Agenda
City of Springboro Planning Commission Meeting
Wednesday, May 8, 2024, 6:00 p.m.
Council Chambers, City Building, 320 West Central Avenue

Background Information & Staff Recommendations
City of Springboro Planning Commission Meeting
Wednesday, May 8, 2024, 6:00 p.m.
Council Chambers, City Building, 320 West Central Avenue

Site Plan Review, 245 South Pioneer Drive, Buckeye Fabricating, building addition

Final Development Plan, 1525 South Main Street (SR 741), Northampton PUD-R, Planned Unit Development-Residential, residential subdivision

SITE PLAN & NOTES
C-1.1

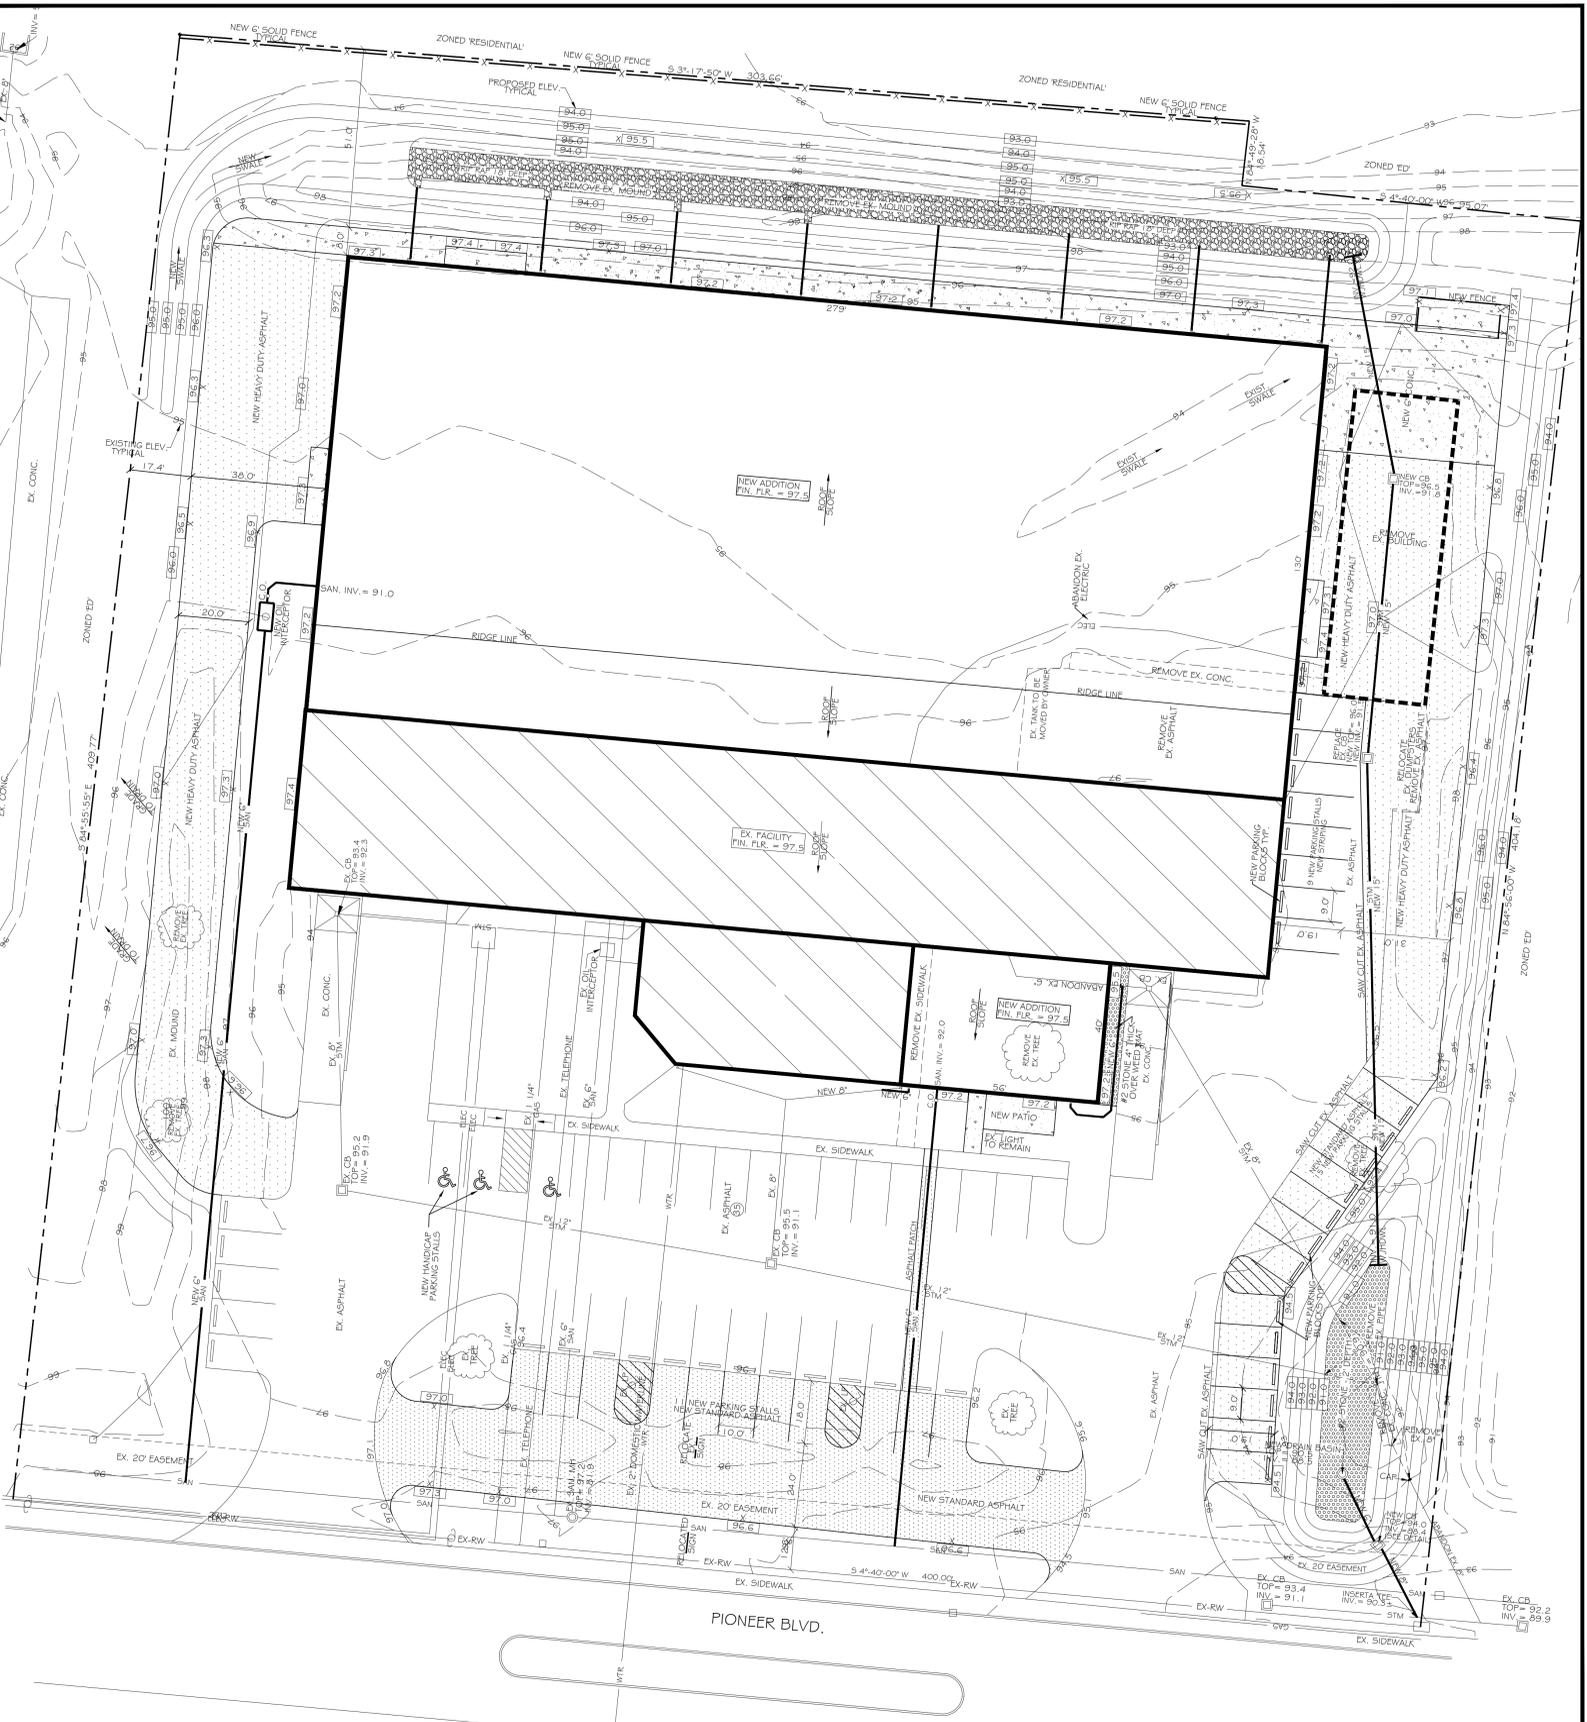
1. Provide specs for proposed lighting on building/site. Photometric analysis acceptable.
2. Signage including directional signage to be reviewed with Zoning Inspector separate from the site plan review process.
3. Elevations and contours shall be based upon USGS datum and identify benchmark utilized.
4. Provide proposed storm sewer pipe lengths with slopes. Add structure in lieu of Inserta Tee at detention outlet.
5. Drainage calculations are under review.

6. Provide sanitary sewer lateral pipe lengths.
7. Call out dumpster pad location on site plan along with dimensions.

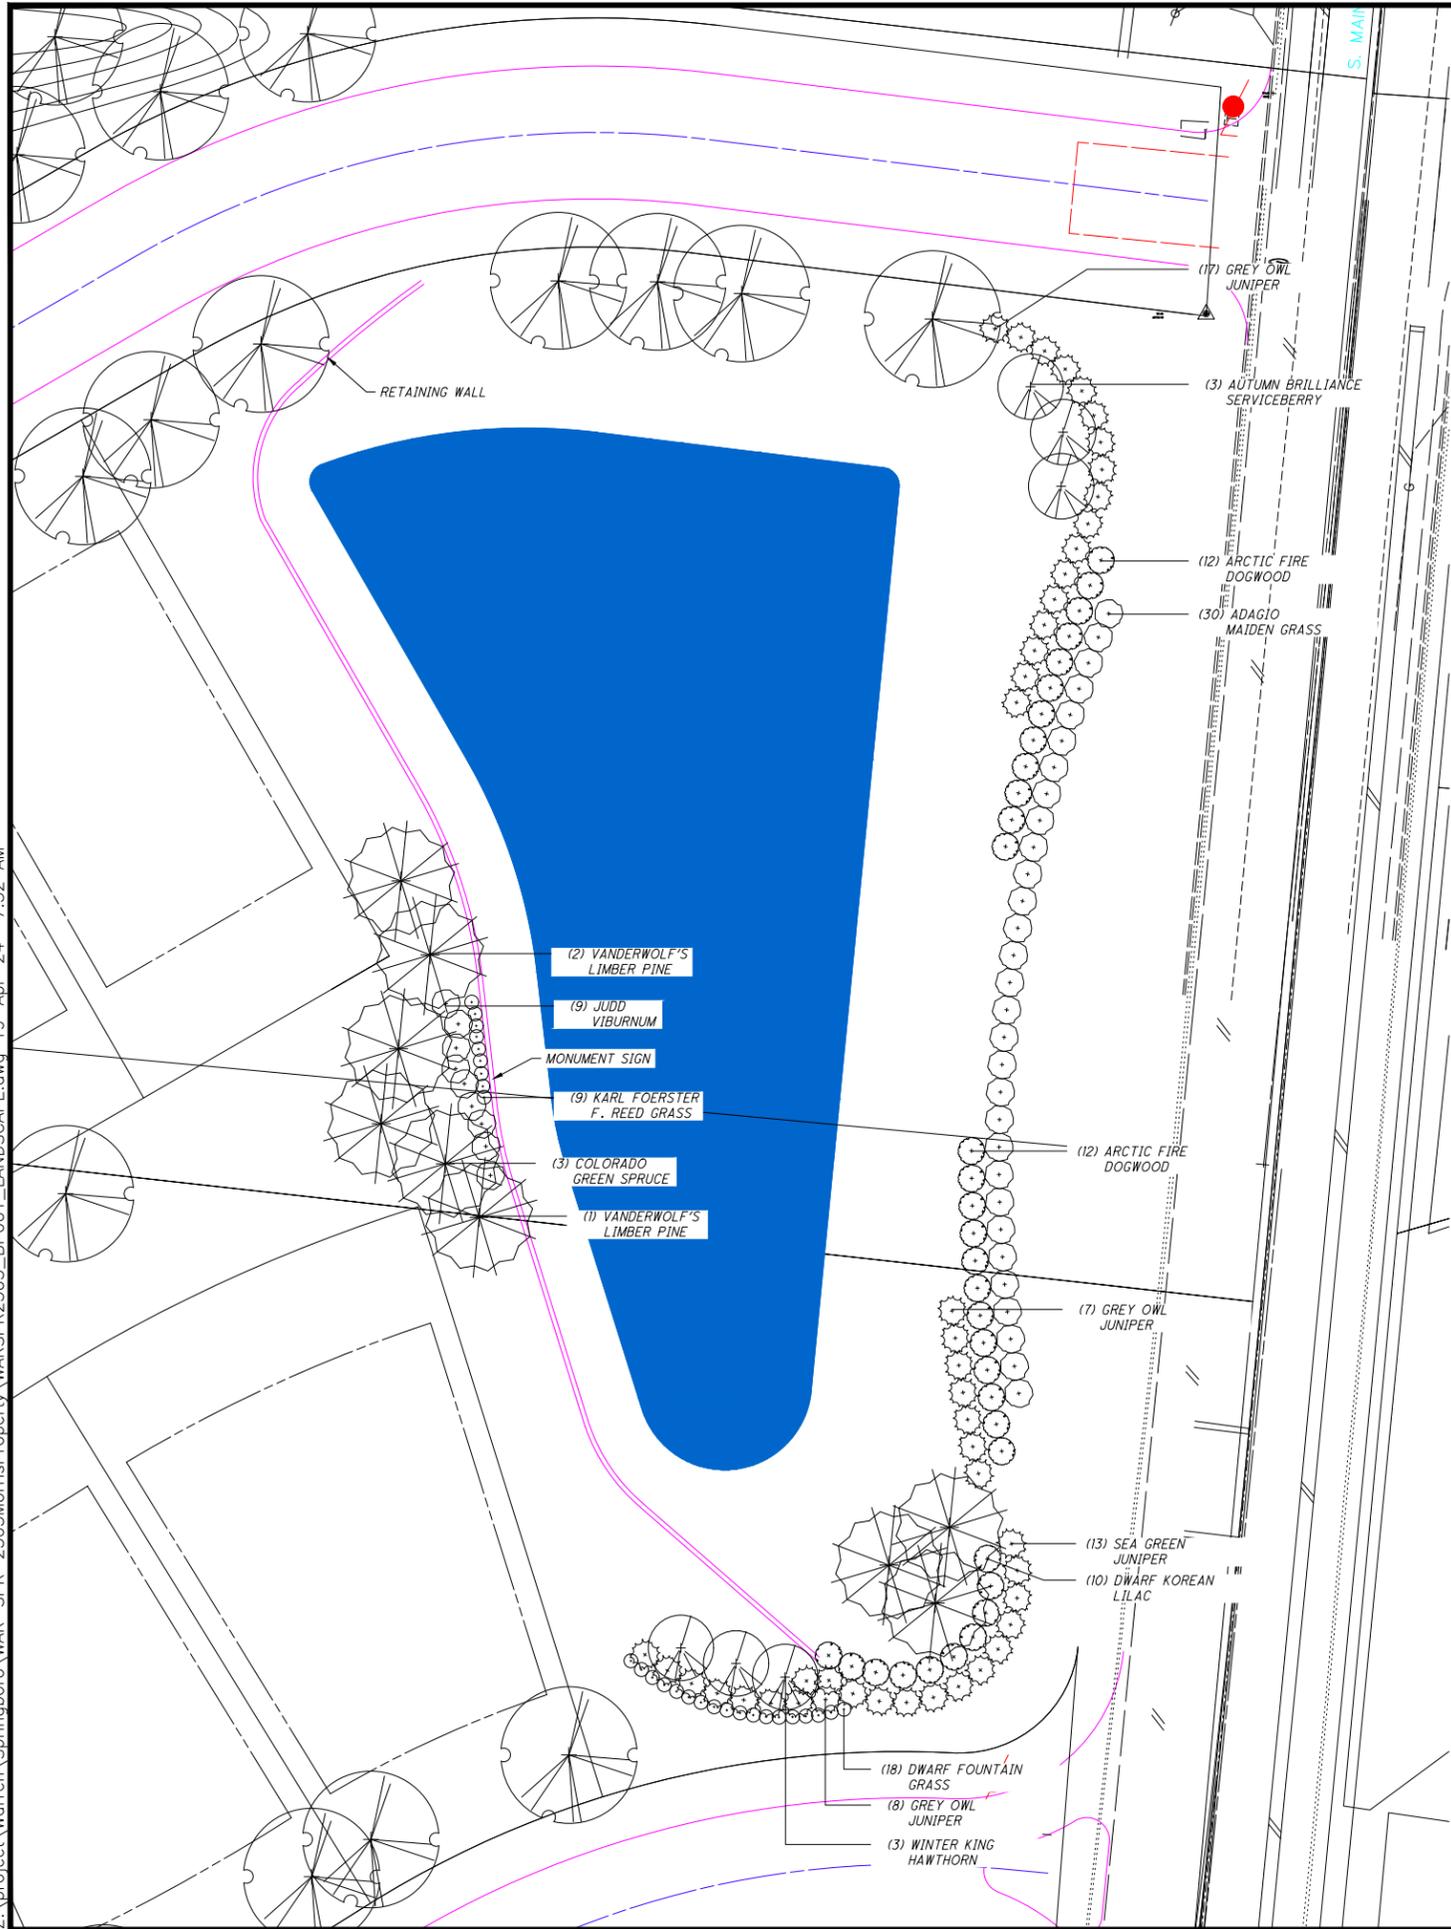
- a. Existing trees identified on sheet 10 of 12 account for an equivalent of 482 trees.
Applicant to commit to those trees' maintenance through the construction phase of the subdivision. These trees may be used against landscaping deficiencies in the plan except for street frontage and lot landscaping requirements.

- a. Existing trees identified on sheet 10 of 12 account for an equivalent of 482 trees. Applicant to commit to those trees' maintenance through the construction phase of the subdivision. These trees may be used against landscaping deficiencies in the plan except for street frontage and lot landscaping requirements.

10 OF 11

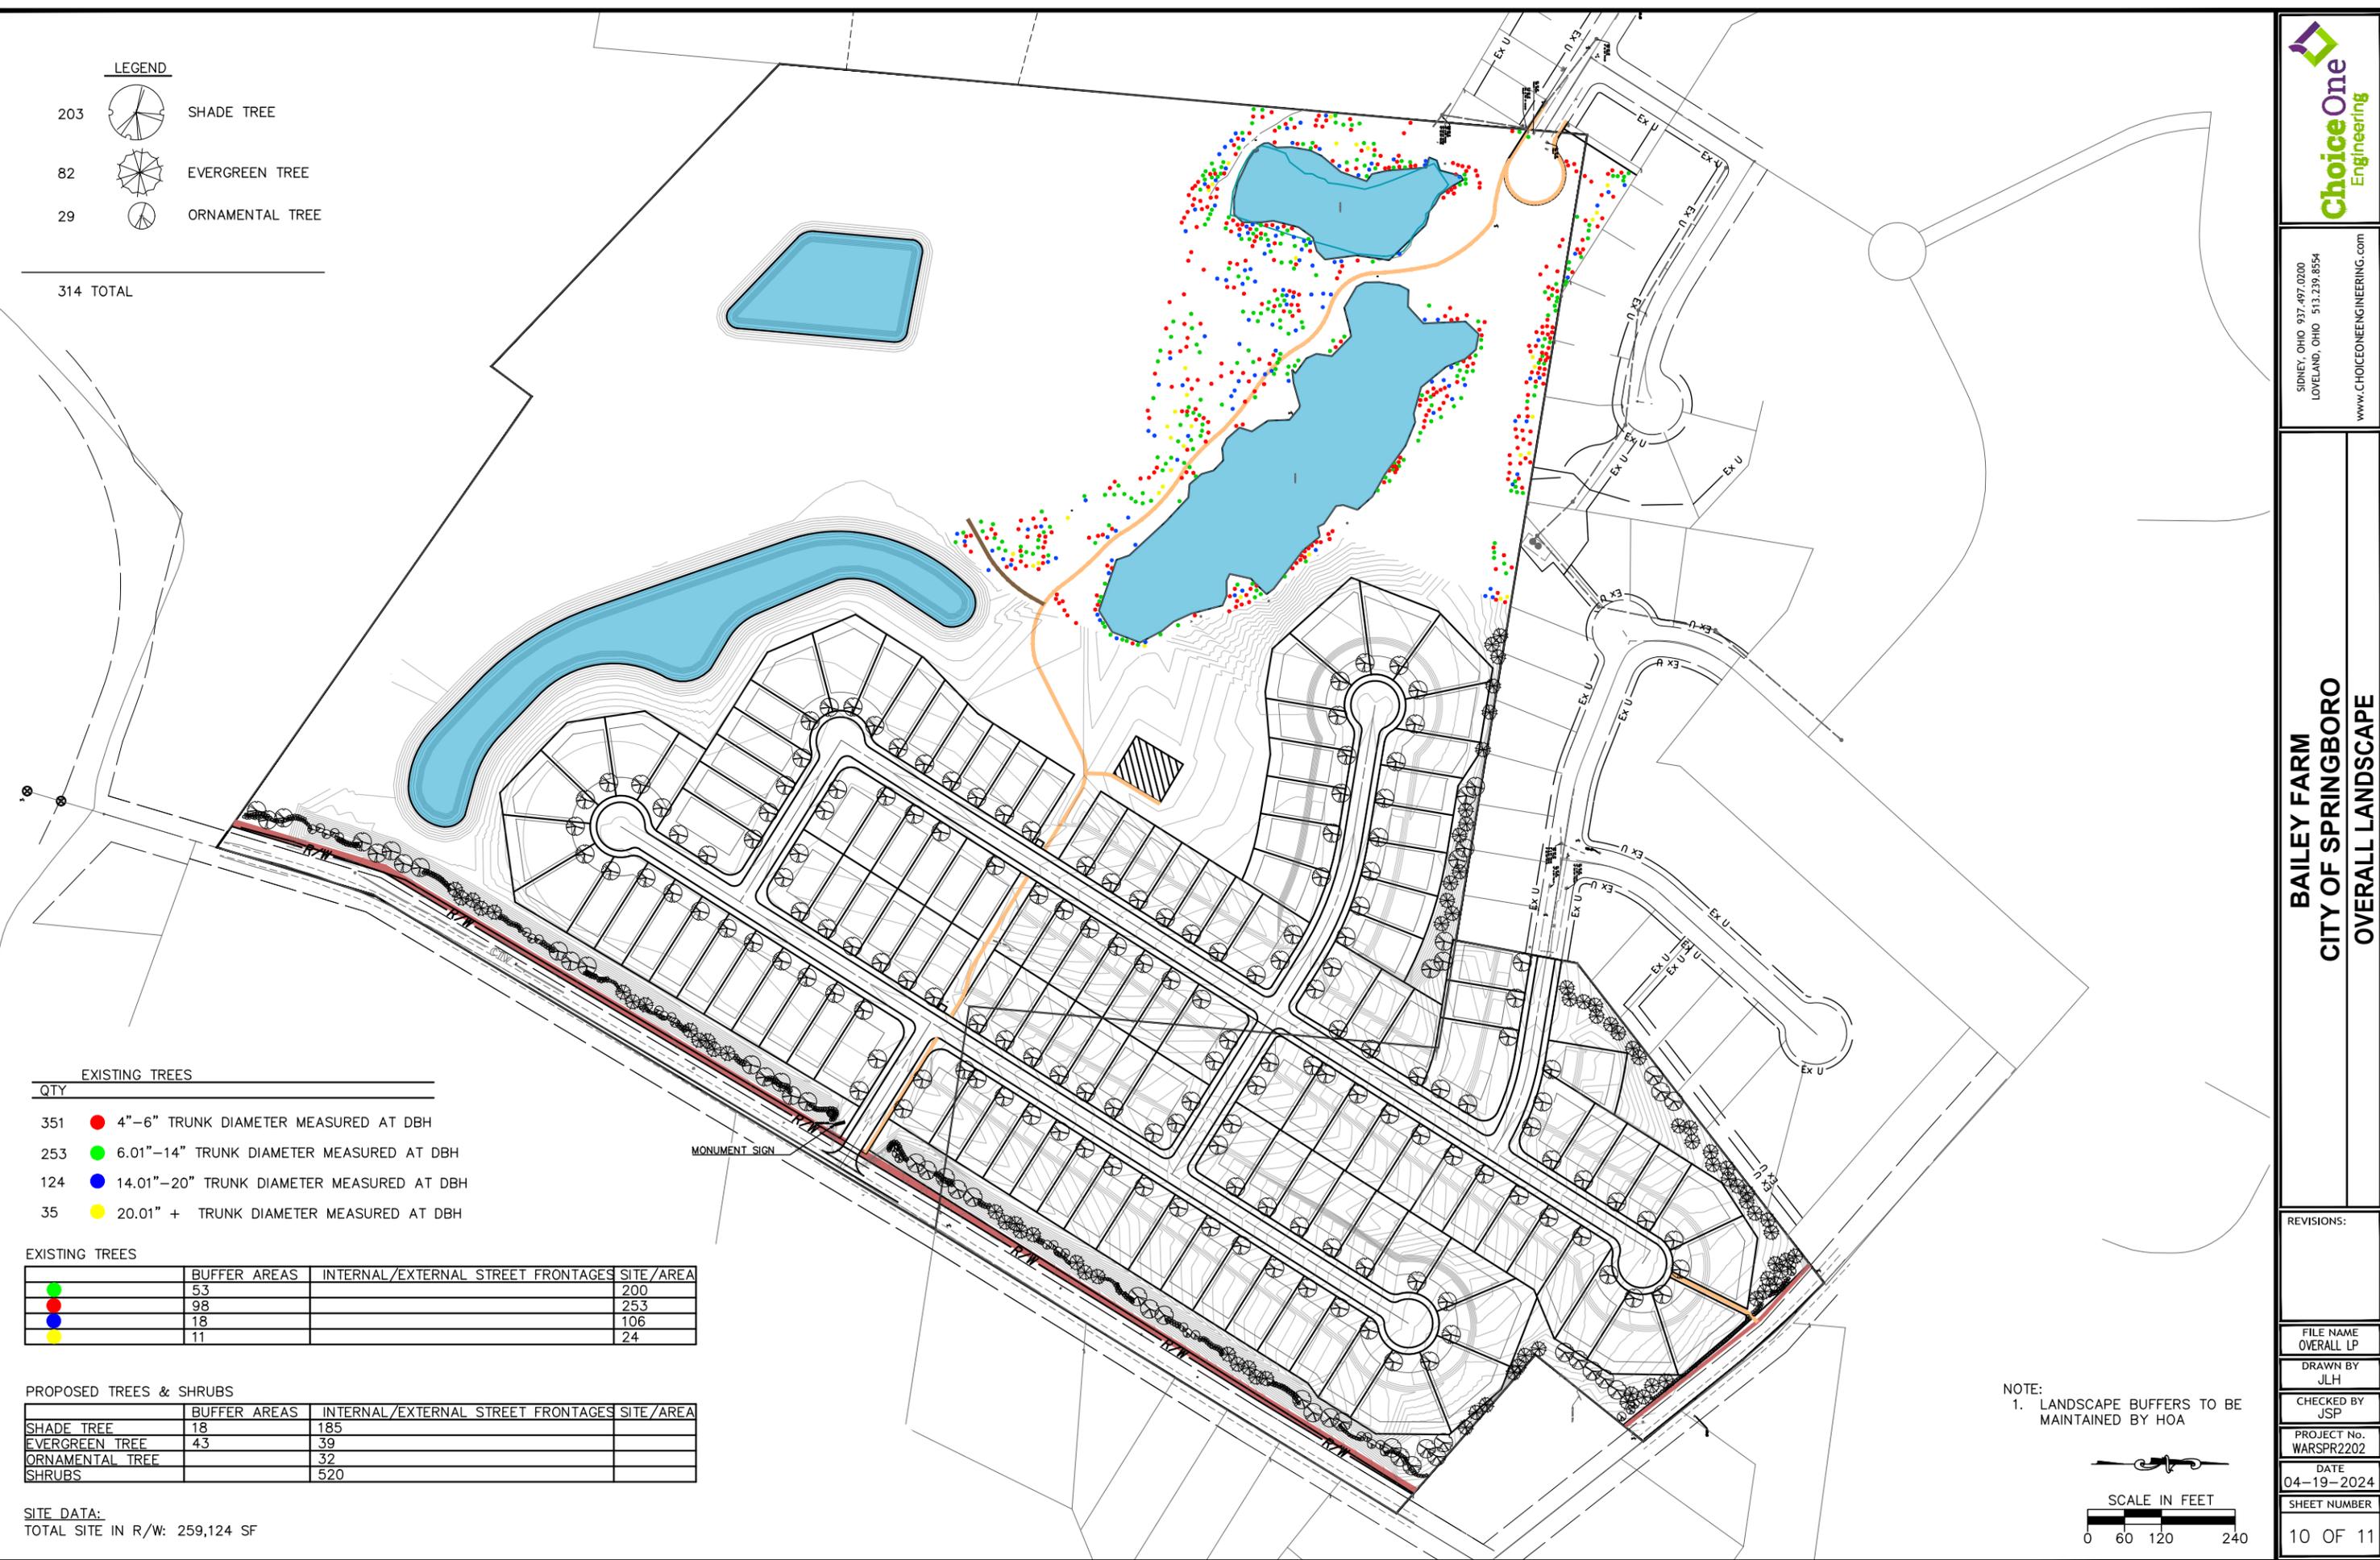
2. Revise information on sheet 3 of 11 to reflect on-site open space.
3. The following comments apply to the proposed landscaping plan:
 - a. Provide metes-and-bounds to sheet 10 of 11.
